Summary of Comments from Previous Meetings

DEVIL'S GATE DAM ENTRANCE - CONCEPT 1

Southeast Entrance Improvements

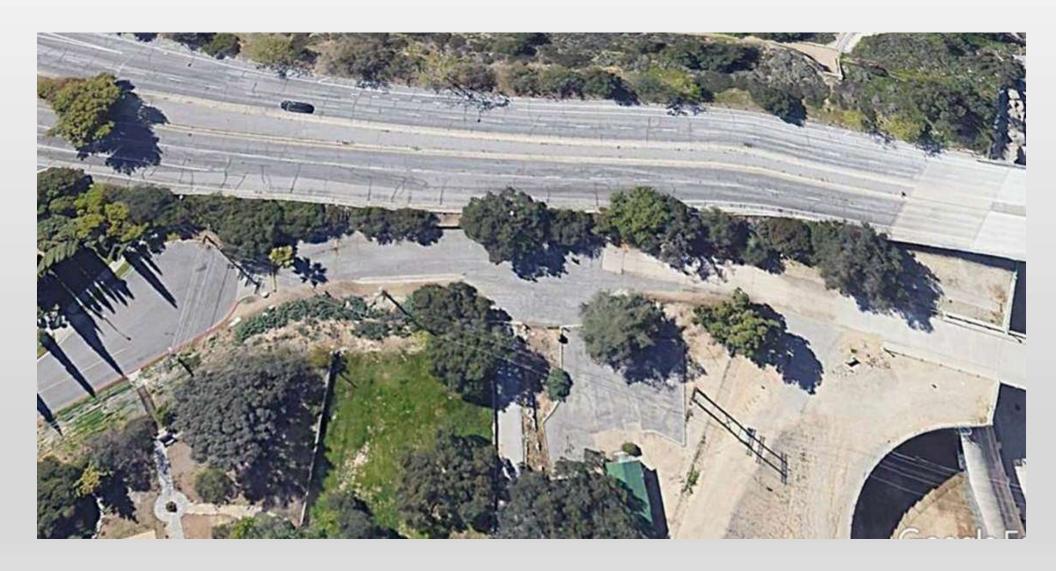
- Teardown/refurbish old building & chain link fence
- Remove one of the new vehicle entrances – Slip lane & bike safety
- Remove concrete/repave with natural materials
- No benches discourage loitering

- Return entrance path to lower grade/Use natural materials for a barrier rather than chain link fence
- Boulder/Bollards may not stop
 4x4 trespassing & damage to new plants
- Work with City of Pasadena to improve bike/pedestrian/vehicle safety on Oak Grove
